SERVICE BULLETIN

PRODUCT: COMPUTER MONITOR
BULLETIN: MONITOR 95-007
MODEL: CQB4147

SUBJECT: No Raster

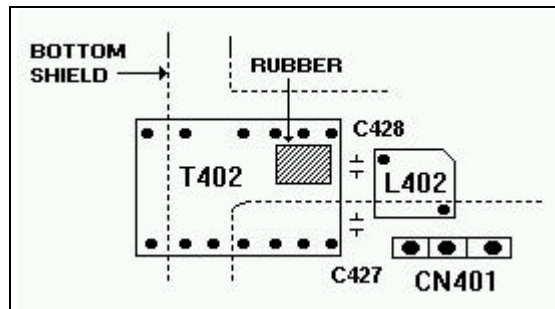
BACKGROUND: A whistling sound is created from harmonic noise generated between T402, L402, and the main PCB near the Flyback Transformer.

SOLUTION: Add a piece of rubber to insulate the main PCB solder side from the bottom metal shield. See Illustration below showing the section of the PCB where the rubber will be located.

Part No.	Description
BH61-30303A	RUBBER

Figure 1

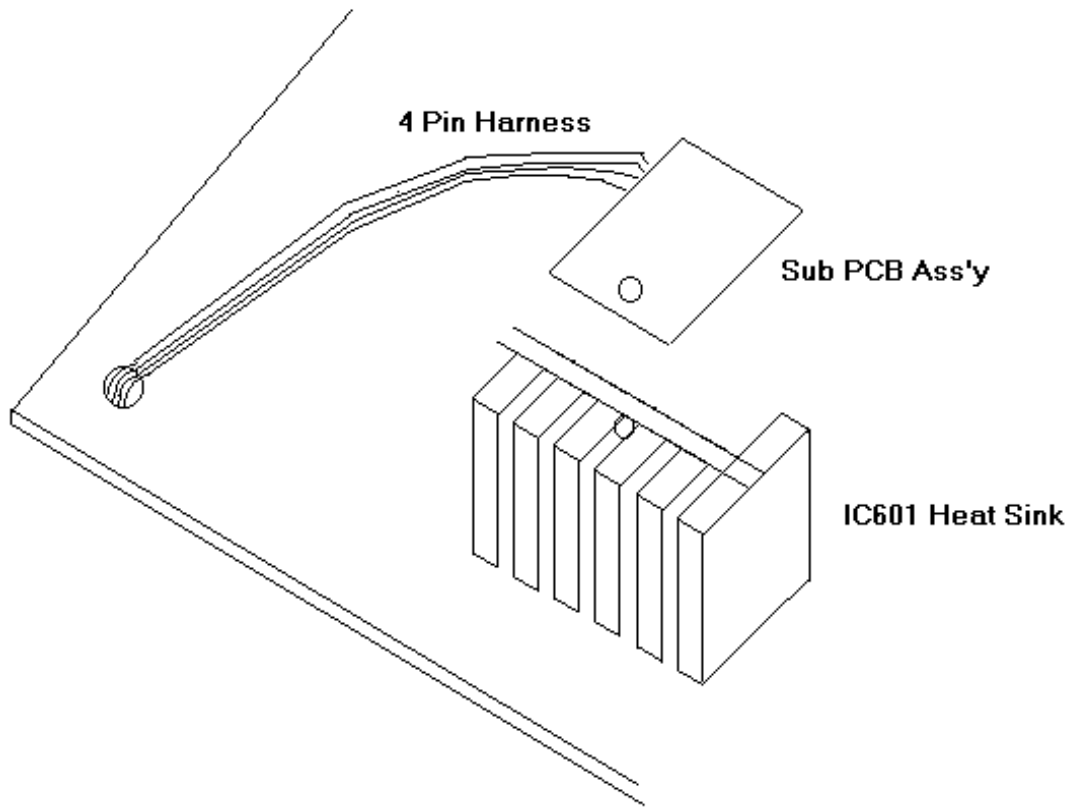
BACKGROUND: Q407 fails due to a transient pulse and current when mode switching from DOS to Windows. This occurs with a Matrox video card installed in the computer.

SOLUTION: Add a sub-PCB assembly as in figures 1 and 2 and a snubbing circuit for the horizontal output as in figure 3.

ORIGINAL			NEW	
Location No.	Part No.	Description	Part No.	Description
NA	NA	NA	BH92-50106J	SUB-PCB ASSEMBLY
NA	NA	NA	BH39-40355S	4 PIN CBF-HARNESS
NA	NA	NA	6003-000129	TAPTITE SCREW
NA	NA	NA	0401-000005	1N4148 DIODE
NA	NA	NA	0402-000012	UF4007 DIODE
NA	NA	NA	2003-000009	220 OMHS, 1 WATT
